**SAR Chapter 2, “Site Characteristics”****RAI NP-2.6-3:**

**Figure NP-2.6-3-1  
Historical Borings at WCS Site**

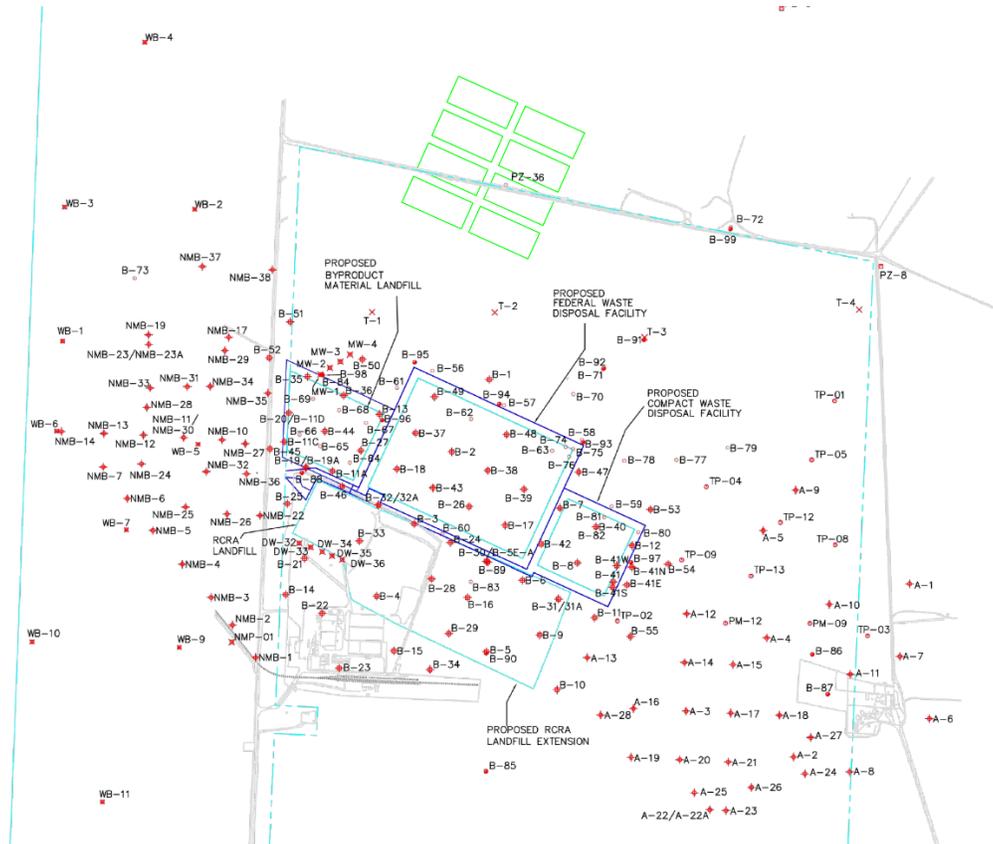
Provide justification for why soil boring to depths greater than 45 feet are not needed.

WCS CISF SAR Section 2.6.4 states that the WCS CISF subsurface conditions were explored with eighteen soil borings. Among the eighteen borings, four borings encountered auger refusal conditions at depths ranging from 37 to 45 feet below ground surface (bgs), and fourteen borings were terminated at 25 feet bgs. General industrial guidance for geotechnical investigations, such as US Army Corps of Engineering<sub>1</sub> and FHWA<sub>2</sub> manual/standard, recommends the boring depth, for example, (1) be at least to a depth where the increased stress due to the estimated footing load is less than 10% of the existing effective overburden stress, (2) be 1.5 times the minimum dimension of footing below the base of the footing, or (3) penetrate a minimum of 3 meters into the bedrock, if bedrock is encountered before other required depths.

Four of the eighteen borings performed for the CISF project encountered auger refusal. The auger refusal depths ranged from 37 to 45 feet below the ground surface (bgs). Borings can be extended to a greater depth in order to obtain the soil parameters or shear wave velocities can be used to extend the soil parameters necessary for settlement analysis. In this case, shear wave surveys were performed in conjunction with the geotechnical exploration and shear wave velocities are provided to depths of 100 feet bgs. Additionally, multiple previous geotechnical investigations have been performed at the site as well as shear wave testing. The historical data outlined below were utilized to extend the soil profile and engineering parameters to a depth of 600 feet. This depth satisfies general industry guidance for settlement evaluation depth. The depth of 600 feet was selected as the termination depth due to encountering the Trujillo Sandstone Layer.

The information from the eighteen borings and shear wave data included in the Report of Geotechnical Exploration (Attachment E to Chapter 2 of the SAR) was supplemented with data obtained from References [2], [3], and [4]. These data were used to produce a soil stratigraphic column to 600 feet along with the necessary engineering parameters required for settlement analysis. Figure NP-2.6-3-1 displays the locations of the historical borings provided.

**Figure NP-2.6-4-1  
Historical Borings at WCS Site**

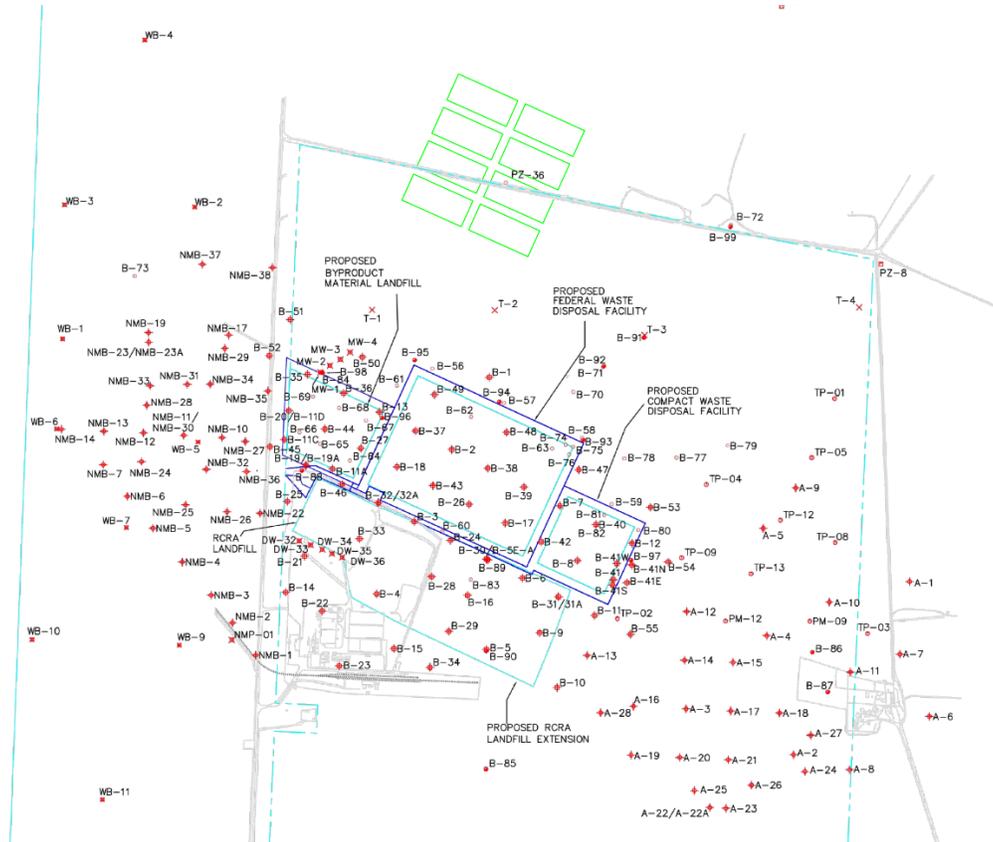
- a. Justify how the soil strength and deformation properties of the cohesive soils were determined and how the settlement potential of the clay stratum can be adequately evaluated given the absence of consolidated undrained triaxial tests and consolidated tests.
- b. Provide results from the California Bearing Ratio (CBR) testing.
- c. A description of the laboratory tests (including the test results) that were completed after the submittal of the Geotechnical Exploration Report (Attachment E to the SAR).

The information from the eighteen borings and shear wave data included in the Report of Geotechnical Exploration (Attachment E to Chapter 2 of the SAR) was supplemented with data obtained from References [2], [3], and [4]. These data were used to produce a soil stratigraphic column to 600 feet along with the necessary engineering parameters required for settlement analysis. Figure NP-2.6-4-1 displays the locations of the historical borings provided.

**Figure NP-2.6-5-1**  
**Graphical Representation of Constrained Modulus to NPT N-Values from Reference [1]**

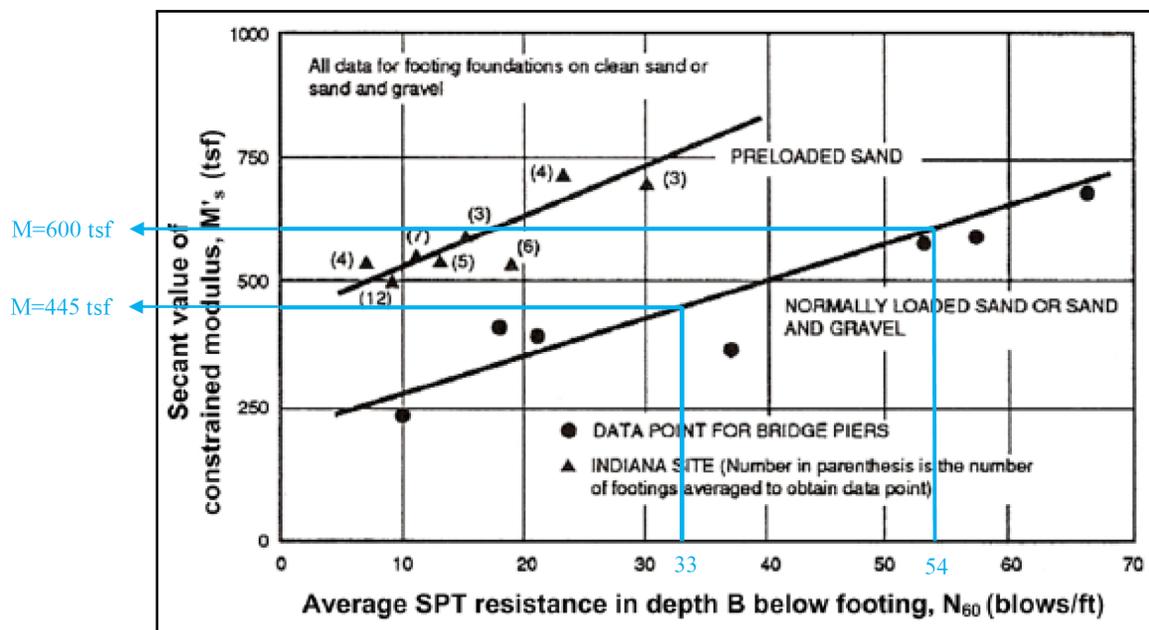
Provide the basis for using 20% of the dynamic modulus for the static elastic modulus as these values are considerably higher for similar soils.

To a depth of 20 feet bgs the constrained modulus was correlated to the Standard Penetration Test (SPT) N-values obtained in the borings. The SPT N-Values were correlated to constrained modulus (elastic modulus) using the method outlined in Reference [1]. This methodology allows correlation of constrained modulus to N-value for N-values up to 70 blows per foot. The graphical representation is provided in Figure NP-2.6-5.

**Figure P-2.6-3-1**  
**Graphical Representation of Constrained Modulus to NPT N-Values from Reference [1]**

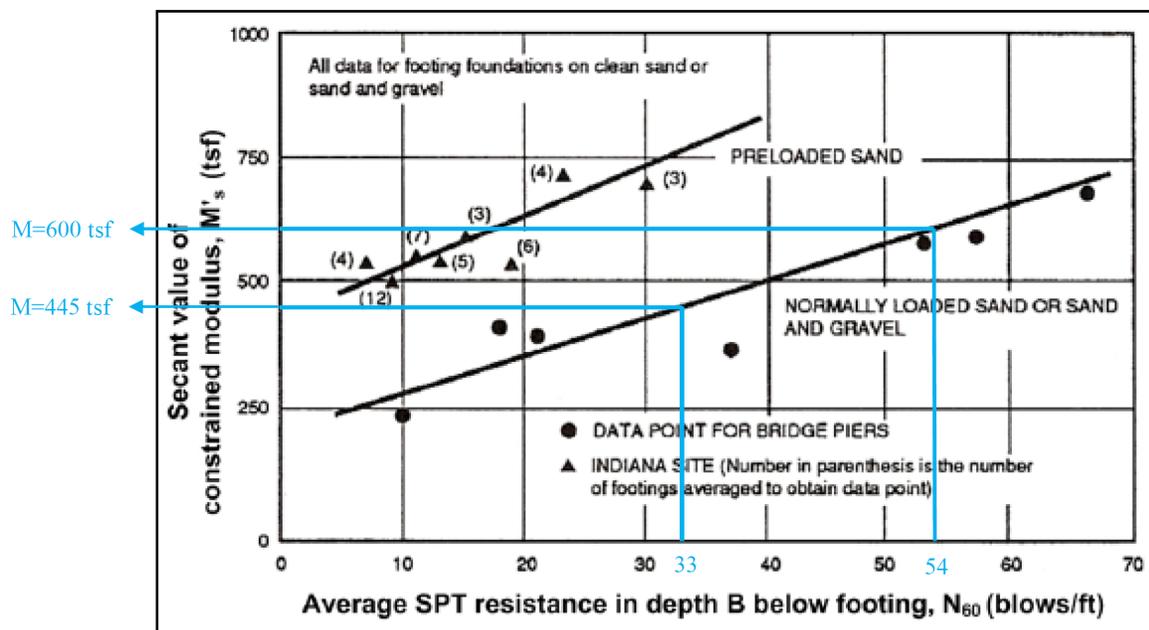
- a. Consistent with proprietary RAI 2.6-1 and non-proprietary RAI 2.6-5, provide the stratigraphic information by depth and associated material properties, including the static elastic modulus values, for the stratum depth causing settlement, and justify the basis of the material properties assigned.
- b. Provide a settlement evaluation for consolidation and secondary compression.

To a depth of 20 feet bgs the constrained modulus was correlated to the standard penetration test (SPT) N-values obtained in the borings. The SPT N-Values were correlated to constrained modulus using the method outlined in Reference [1]. This methodology allows correlation of constrained modulus to N-value for N-values up to 70 blows per foot. The graphical representation is shown in Figure P-2.6-3-1 (Figure 5.4 of Reference [1]).
